Addendum

DS2.1, 2003-08-04

DELIC-LC/DELIC-PB

DSP Embedded Line and Port Interface Controller PEB 20570/PEB 20571/PEF 20570/PEF 20571 Version 3.1

Figure 1 Clocking the VIP by using DELIC Layer 1 Clock

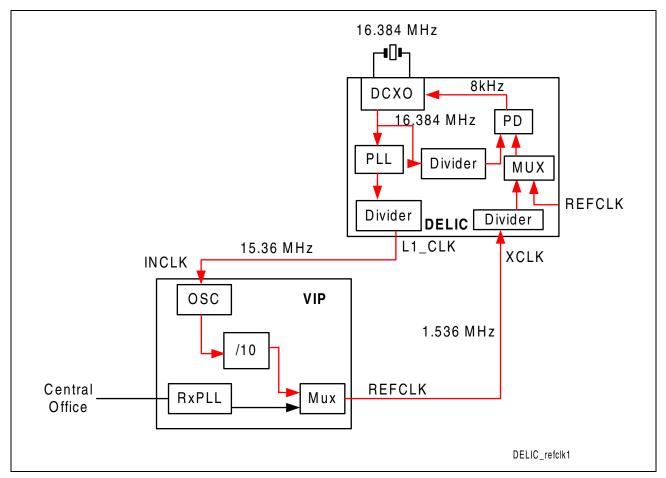
When the Central Office is activated, its clock signal is retrieved by the RxPLL of the VIP and a 1.536 MHz reference signal is generated and used as input signal for the DELIC DCXO (pin XCLK). This signal is divided down to 8 kHz and used as input for the DCXO phase detector (PD). The second input to PD is another 8 kHz signal which originates from the 16.384 MHz output of the DCXO.

The DELIC PLL multiplies the 16.384 MHz DCXO signal up to 61.44 MHz. A divider generates the 15.36 MHz layer 1 clock which is used to clock the VIP.

When the Central Office is deactivated, the VIP takes its oscillator signal of 15.36 MHz (the DELIC Layer 1 clock) divided by 10 and uses this signal as DELIC XCLK input as replacement of the Central Office clock.

As a consequence, the DELIC DCXO gets its own signal as input for the PD. Since the second PD input is also generated by the DCXO, the PLL system is unstable. This results in the DCXO and the PLL running to its respective corner frequency. Therefore, the 100 ppm clock accuracy, required by ITU-T I.430, cannot be guaranteed during this time. When switching to another clock source (REFCLK), the DELIC DCXO will work properly again.

The time within the DELIC DCXO guarantees the 100 ppm clock accuracy varies, depending on various conditions. When the central office deactivates, the user will be notified by the DELIC. It is up to the user to provide another clock source (for example REFCLK) for the DCXO as soon as possible.

Figure 2 Clocking the VIP by using external Crystal

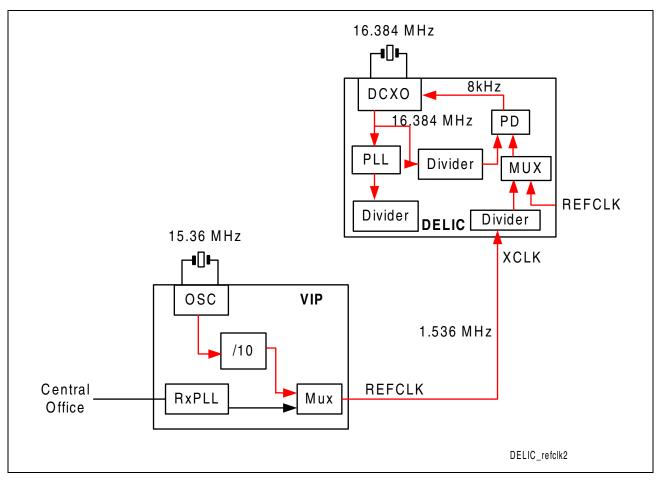
As shown in **Figure 2** no unstable system can occur by using an external crystal rather than the DELIC Layer 1 clock as VIP clock source in LT-T mode. When the central office line is deactivated, the VIP takes the 15.36 MHz oscillator signal and divides it by 10. This signal is used as XCLK input of the DELIC DCXO. Since the VIP 15.36 MHz signal is entirely independent from the DELIC clocking system no unstable system can occur.

Note: In LT-T mode it is recommended to use an external crystal to clock the VIP.

Figure 3 Connecting the Crystal to the DELIC

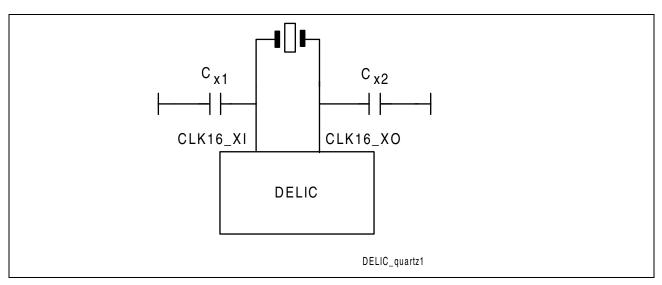
The following table and figures should be taken as an replacement of the "Recommended 16.384 MHz Crystal Parameters" of the DELIC-LC PEB 20570/PEF 20570 and DELIC-PB PEB 20571/PEF 20571.

The DELIC PLL pulls the external crystal by adding/substracting capacitors (internal). By default, half of the internal capacitors are switched on at each pin (CLK16_XI and CLK_16XO).

Attention: On the DELIC Evaluation Board (SMART 2057, Infineon) C_{x1} and C_{x2} are 3.3 pF each. This value can be used as reference, but depends on the respective board design (for example layout).

CSTRAP Strap Status Register

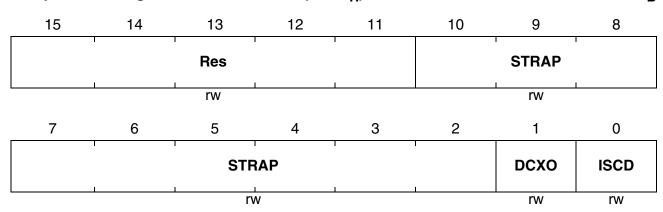
The DELIC "Strap Status Register (CSTRAP)" is described in the DELIC-LC PEB 20570/DELIC-PB PEB 20571 Data Sheet, independent of the version (2.1 .. 3.1). The register description (see updated register CSTRAP) of the Data Sheet is misleading concerning bit 0 and 1. They are **not** configured by strap option. For a stable DCXO synchronization it is recommended to proceed as follows:

- 1. After Boot read register CSTRAP to detect the value
- 2. Set only bit CSTRAP: DCXO to '0' and set the others as detected before
